RE: **7519 Eagle Rock NE**
Grading Plan
Engineer's Stamp Date: 10/17/19
Hydrology File: C19D042B

Based on the submittal received on 10/17/19, the Grading Plan cannot be approved until the following corrections are made:

I have attached a revised grading & drainage plan that addresses your comments of 9/25/2019 as follows:

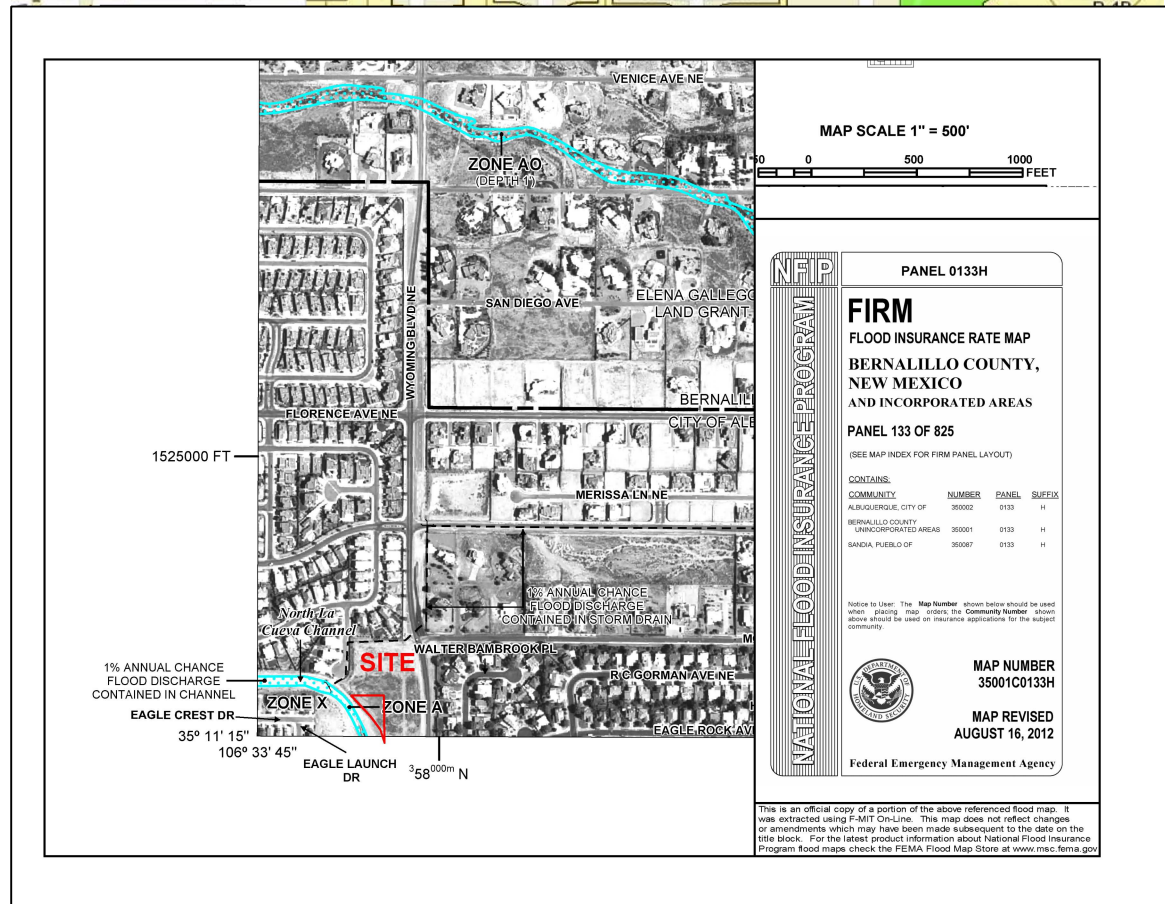
2. This site is in Precipitation Zone 3, not 2. *Hydrology calculations have been revised to Zone 3.*
3. Stormwater quality (SWQ) volume should be calculated as 0.34" x impervious area, but there is no SWQ requirement for individual homes, so the SWQ retention may be removed if desired. *The water quality volume has been removed from the pond design*

4. Drastically screen back or remove the image underlay. The plan is nearly illegible. *The background image has been removed.*
5. A digital (.pdf) submittal, emailed to PLNDRS@cabq.gov is required. *The digital submittal of the original plan has been done. The revised plan has also been digitally submitted.*

7. Show/label any proposed walls. Provide sections through all proposed walls showing property/ROW lines, existing, and proposed grades. In accordance with DPM Ch.22, section 5 part B, grading and wall construction near the property line may not endanger adjacent property or constrain its use. *All walls are existing and have been labeled. No new walls are proposed.*

8. The driveway appears to be graded to drain straight into the garage. Provide a means to keep drainage from entering it such as a trench drain or changing the grading. *A drainage swale across the driveway is provided.*

9. Also ensure the building is elevated 1' above surrounding grades, with swales to convey drainage to the pond. Include the spillway elevation for the riprap rundown; should be at least 1' below the finished floor elevation. *Noted. The removal of the background image shows the proposed swales. Design spot elevations are provided to assure the finished floor is at least 1' above the surrounding grades.*
